**ADDENDUM NO. 3
TO
CONTRACT DOCUMENTS**

**STAGE II WASTEWATER TREATMENT PLANT
FLOOD PROTECTION PROJECT**

BID PACKAGE #B06-2022

August 31, 2022

FIGURE A3-1

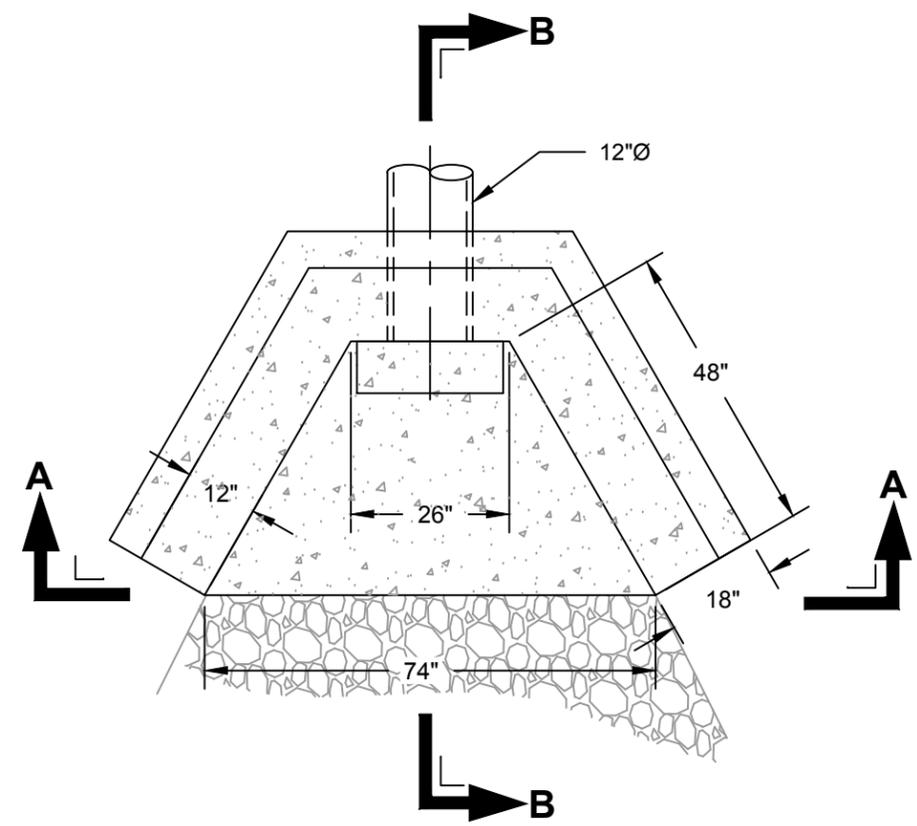
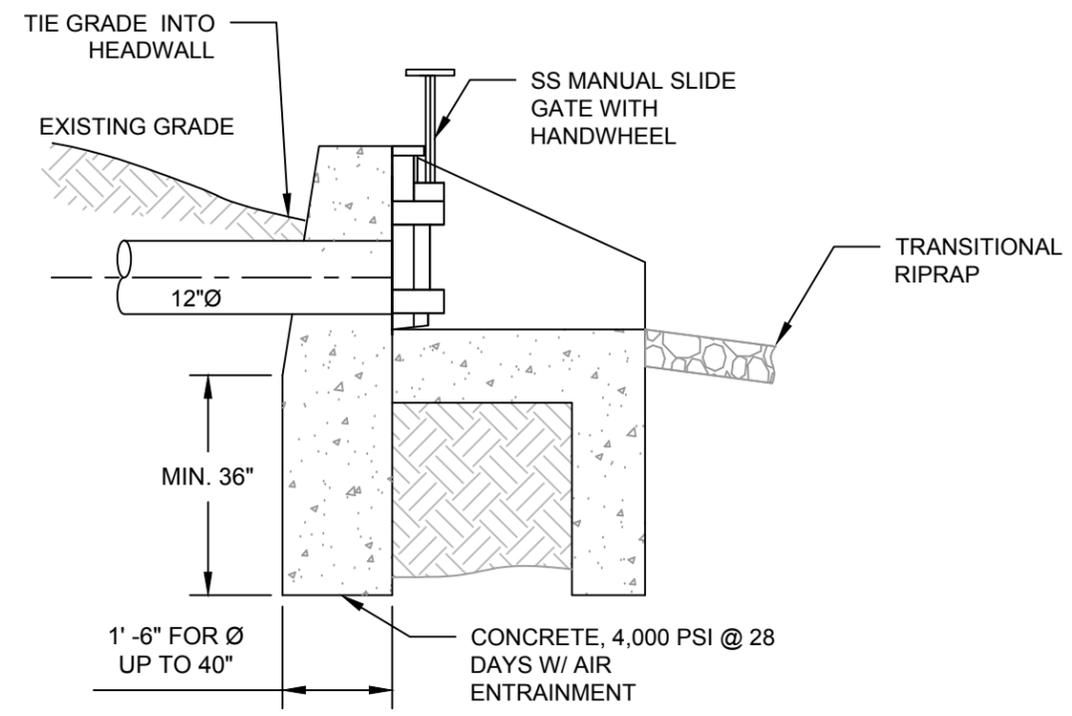
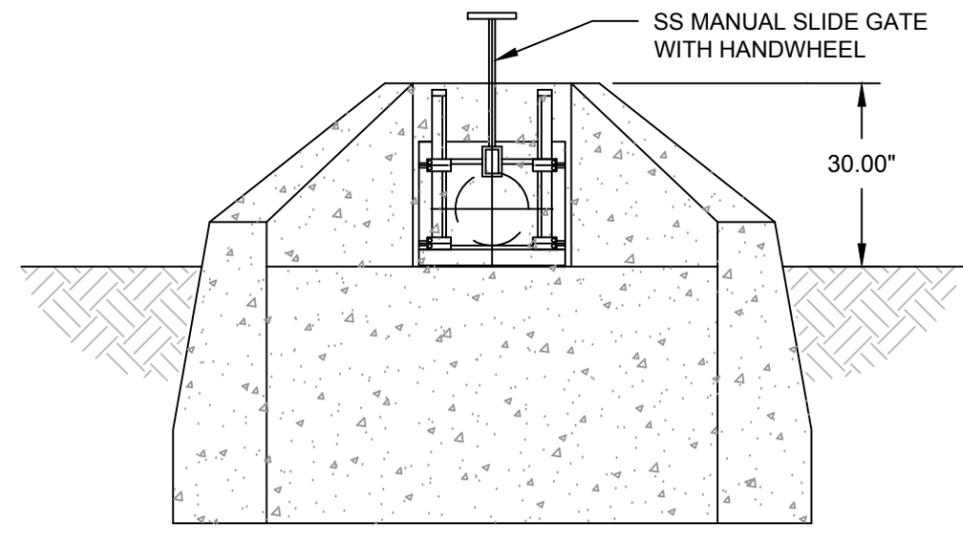
6. Please provide typical details for the Headwalls shown on Dwg C8, along with the Slide Gate and Tide-Flex Valve.

Response: A detail has been prepared for the Headwall for the 12” x 12” slide gate and is attached to this Addendum. Please reference the revised Headwall detail on Sheet C-17 included in this Addendum for updated details for the Headwall outlet and installation of the TideFlex (or equal) check valve.

TYPICAL TRENCH DRAIN DETAIL

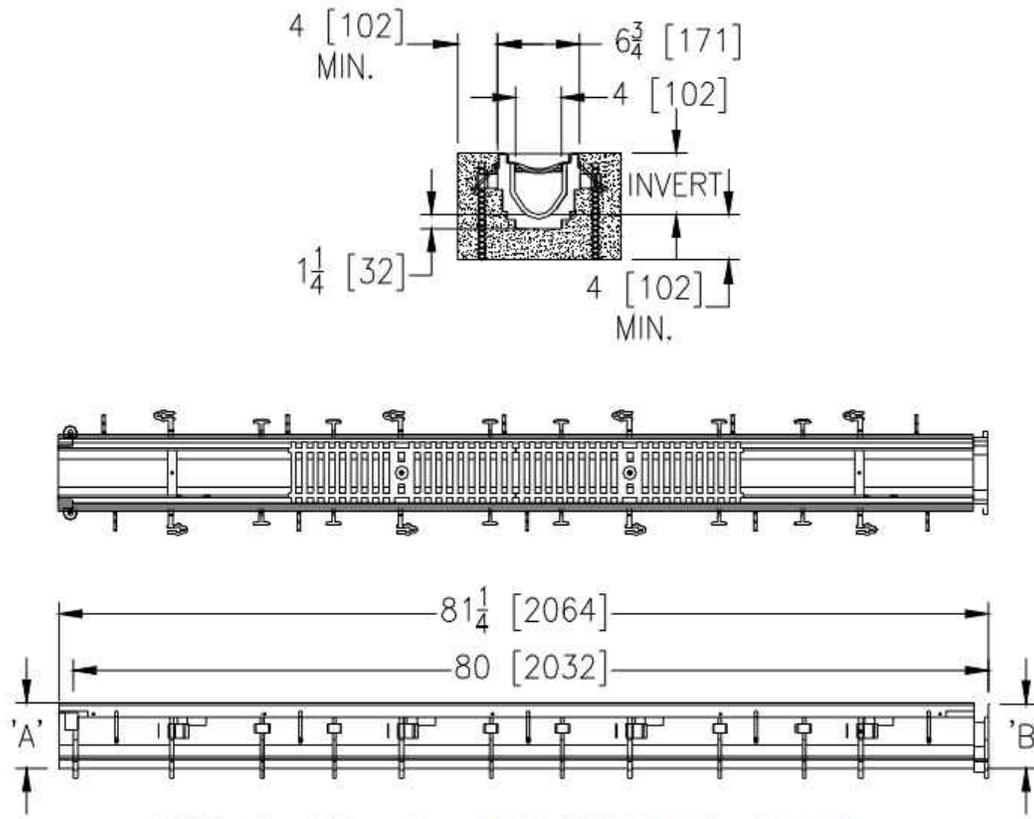
7. With regard to the Storm Drainage on Dwg C9 please clarify the following: (a) please provide typical details for the construction of the Headwall at the Stormwater Outfall that also show the Tide-Flex Check Valves; (b) please provide Rim Elevations and Invert Elevations for all three Manholes; and, (c) provide typical details for the Trench Drain that is to be provided.

verify inverts of existing drain manholes to ensure a minimum slope of 2% is achieved for new drain piping to new drain manholes (3); (c) The trench drain shall be a Zurn model Z886-HDS or equal, refer to the attached trench drain detail included in this Addendum.

FLOOD WALL PROFILE
SCALE: 1" = 40'

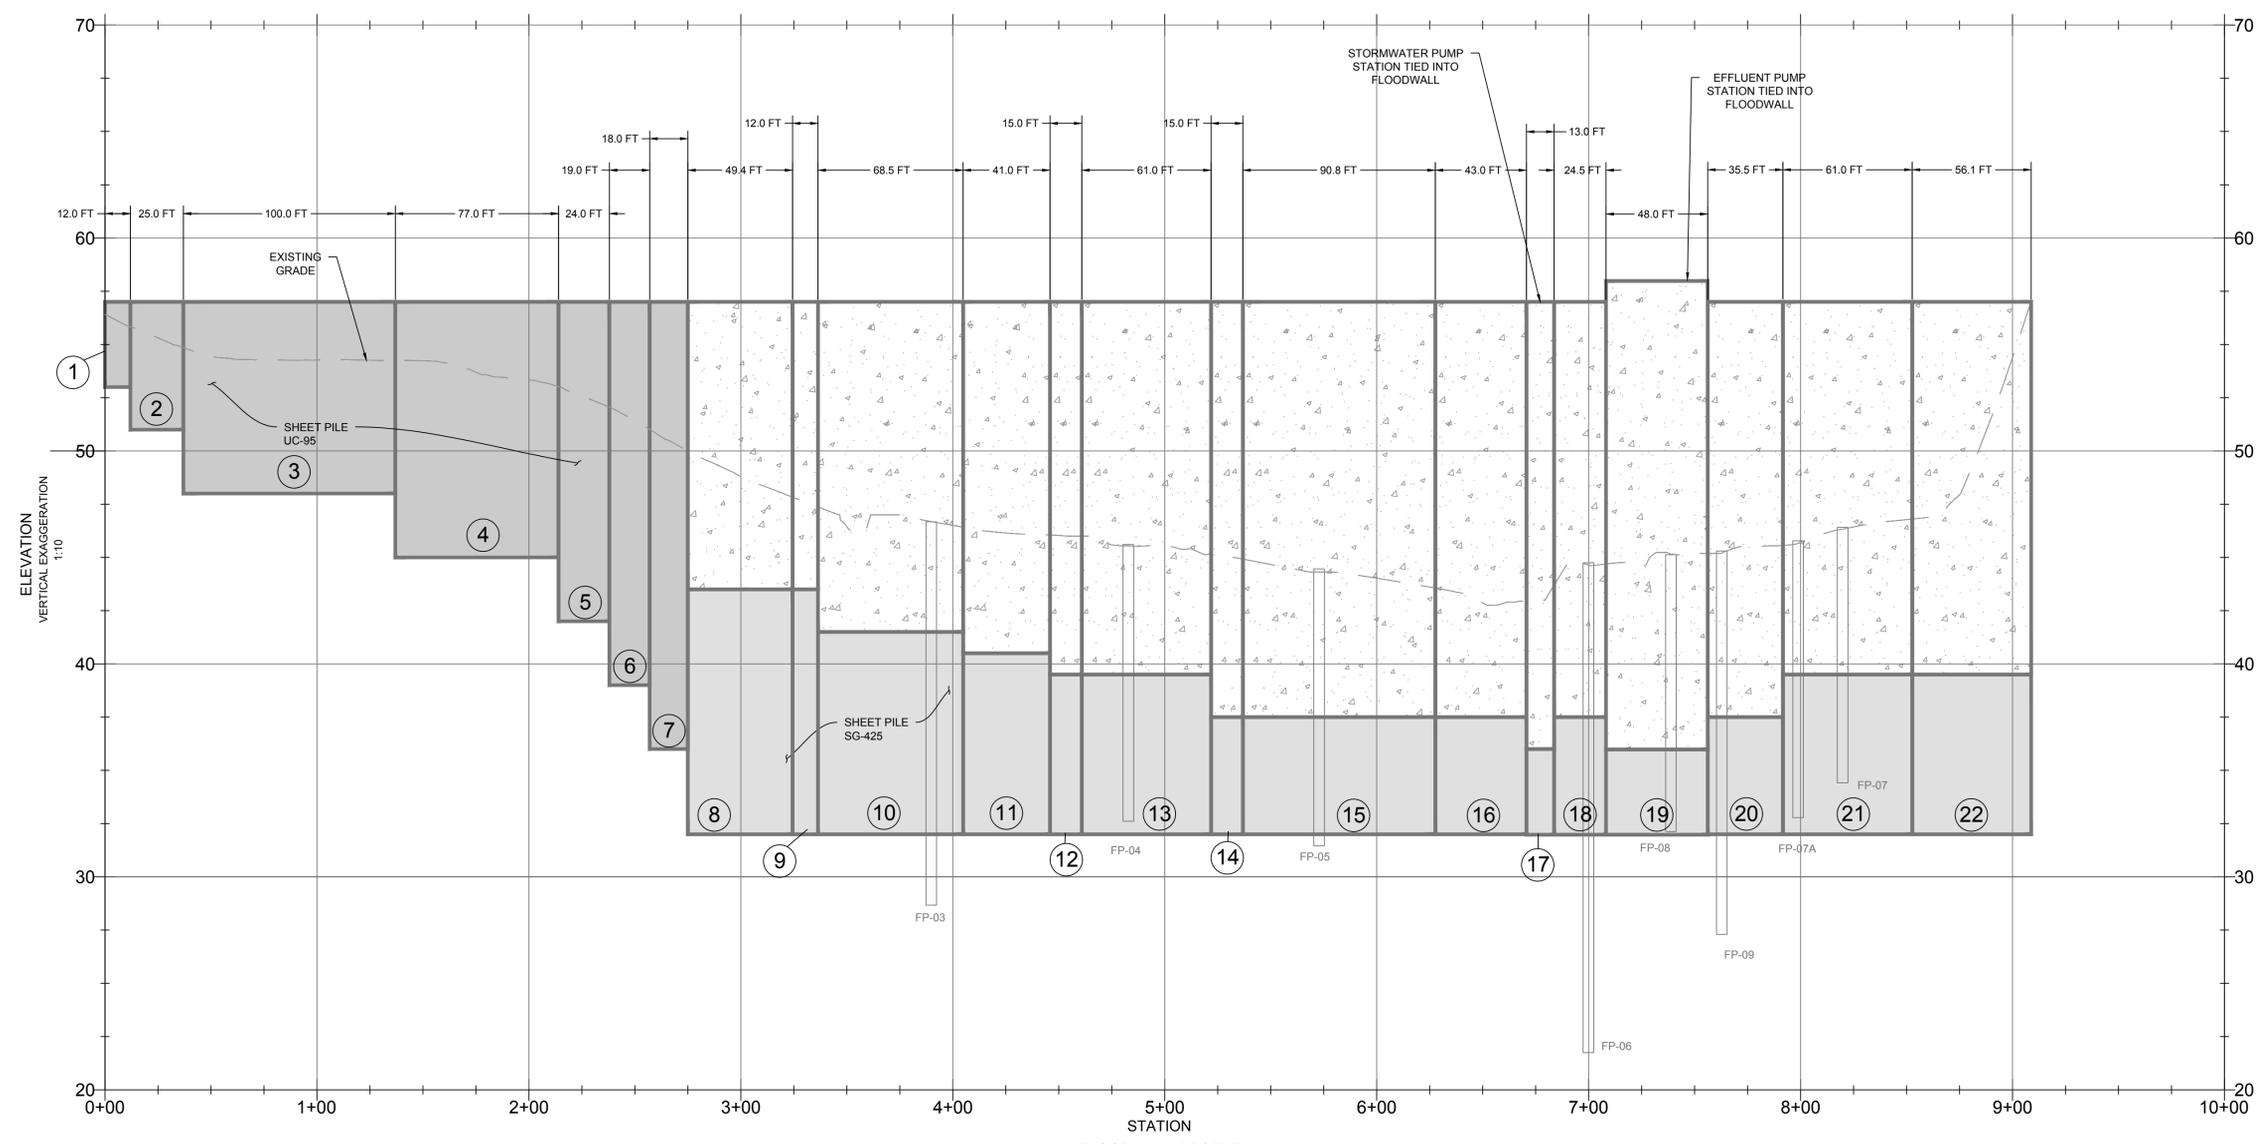
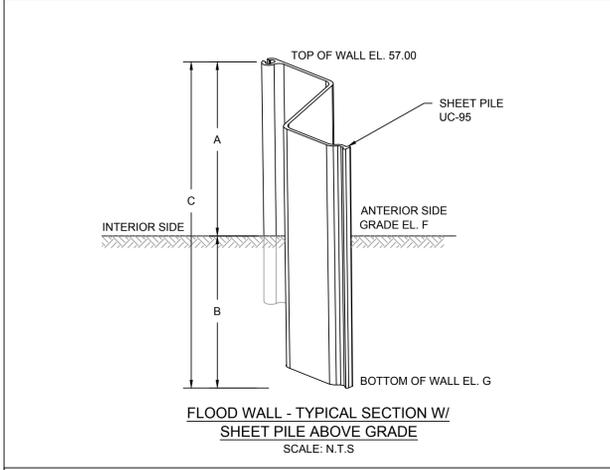
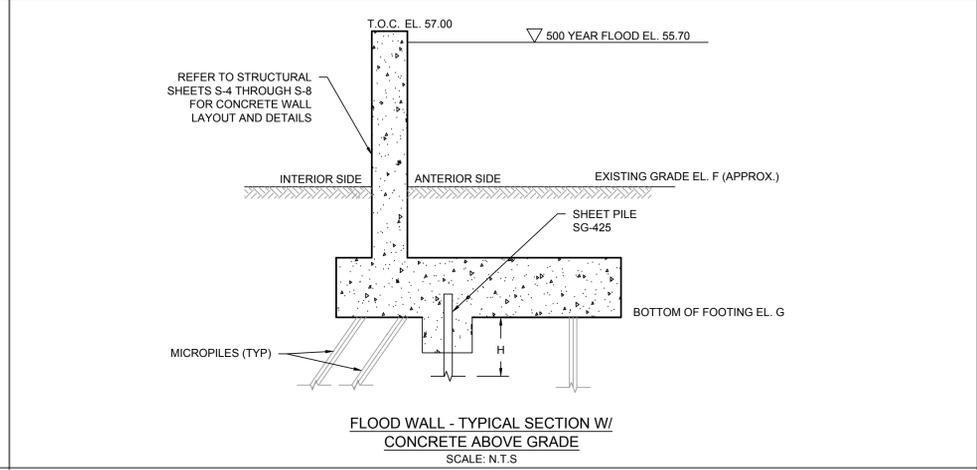
62. Dwg C8 shows an existing underground sewer that crosses underneath the alignment of the proposed Sheet Pile Flood Wall, and no invert elevations or top of pipe elevations are provided for this sewer. Please confirm that the tip elevations of the Sheet Pile Flood Wall will be above this existing sewer

64. With regard to the Concrete Flood Wall, Dwg C13 identifies the locations and lengths for the various types of Walls (Type 1A, Type 1B, Type 2, etc.) and the same Wall Types are identified on the Flood Wall Site Plan Dwg's S2 & S3. However, the lengths of the Wall Types on Dwg S1 & S2 do not correlate with the lengths of the Wall Types provided on Dwg C13. Just one example of this discrepancy is the Type 4 Wall Type that is shown to be 25 feet long on Dwg C13 but is shown to be almost 48 feet long on Dwg S2. Since we believe that Dwg C13 is correct, please revise the Wall Types shown on Dwg's S2 & S3 to correlate with the Wall Types shown on Dwg C13.

Response: As noted on sheet C-7, the existing 24-inch sewer top of pipe elevation at the location of the flood wall crossing is 46.10. The revised sheet C-13 has been attached to this Addendum, noting the bottom of sheet pile flood wall at elevation 48.0.

Response: Sheet C-13 has been revised and is attached to this Addendum.

3. Sheet C-13: Replace this Sheet with the attached revised Sheet. The following revisions have been included with this revised Sheet:
 - Sheet pile wall sections are coordinated with Sheets S-2, S-3, and S-4 to reflect proper depth of concrete footing, footing type, footing thickness, and footing section lengths.

2 SECTION
SCALE: 1/4" = 1'-0"

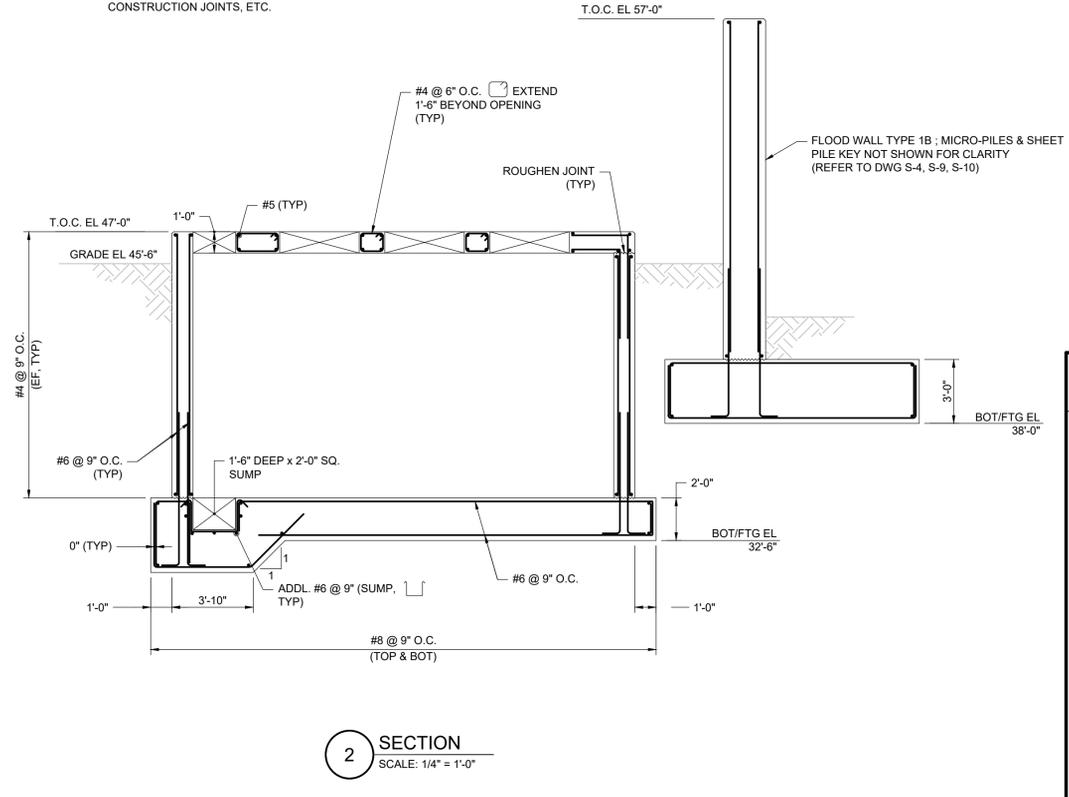
49. Section #3 on Dwg S5 for the Storm Water Pump Station shows the bottom slab of the Storm Water Pump Station extending underneath the footing for the Flood Wall, which complicates the construction of the Flood Wall at this location. However, Section #3/S5 does not show the Keyway and Sheet Pile Cut-Off Wall that are supposed to be continuous through this area according to the notes on Dwg S3. These important design elements need to be shown on Section #3/S5 so that the Bidders and the Contractor can see how the Keyway and Sheet Pile Cut-Off Wall are to be incorporated into this complicated arrangement. Please revise Section #2/S5 to show this important information as soon as possible.

Response: Section 2 on Sheet S-5 has been revised to show the keyway and sheet piling and is included in this Addendum.

PIPING AND EQUIPMENT SCHEDULES
 STAGE II WWTP FLOOD PROTECTION PROJECT
 MONTGOMERY TOWNSHIP
 SOMERSET COUNTY, NEW JERSEY

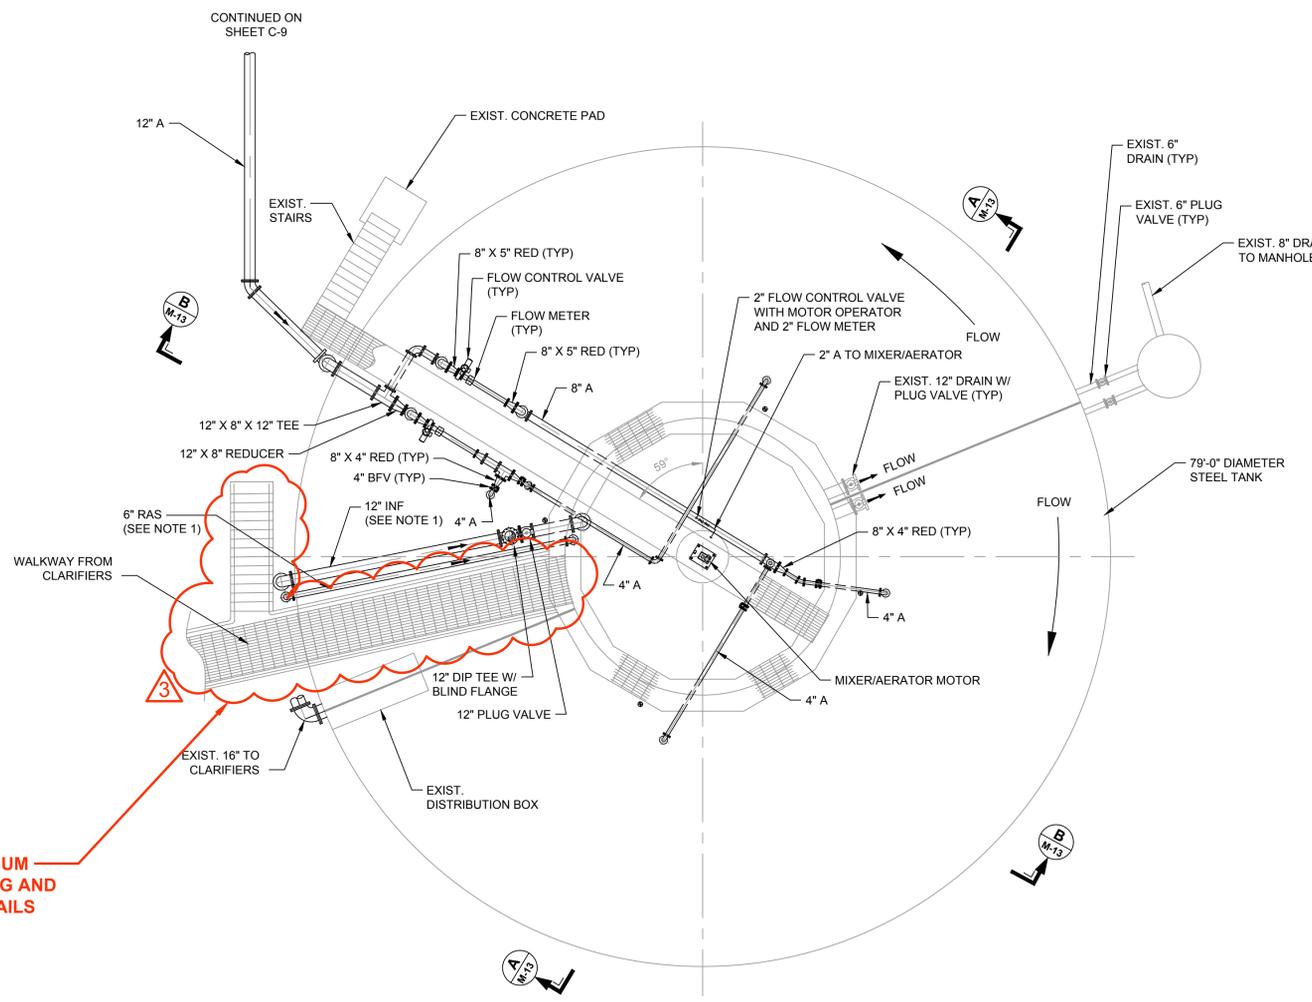
8. Please confirm that the 20" STM FM and the 24" STM Piping from the Stormwater Pump Station to the Stormwater Outfall shown on Dwg C9 is to be made from Ductile Iron Pipe. If this is correct, then please make the necessary revision to the Pipe Schedule on Dwg M2 which indicates that all STM Piping is to be RCP.

10. Please note that the Process Piping Schedule on Dwg M2 does not indicate any Type or Thickness of Pipe Insulation for any new Process Piping, which does not appear to be correct. Please clarify.

Response: The 20" STM Force Main and 24" STM Outfall piping shall be ductile iron. The 8" through 24" STM piping upstream of the Storm Water Pump Station shall be RCP. The Pipe Schedule on Sheet M-2 has been revised accordingly and is included in this Addendum.

Response: On Sheet M-2, Process Piping Note 4 has been revised to refer to Section 15085 – Piping Insulation for piping insulation requirements, and pipe insulation thickness has been added to the Process Piping Schedule.

6. Sheet S-8: Replace this Sheet with the attached revised Sheet which includes revisions to Section 5.
7. Sheet M-2: Replace this Sheet with the attached revised Sheet. The following revisions have been included with this revised Sheet:
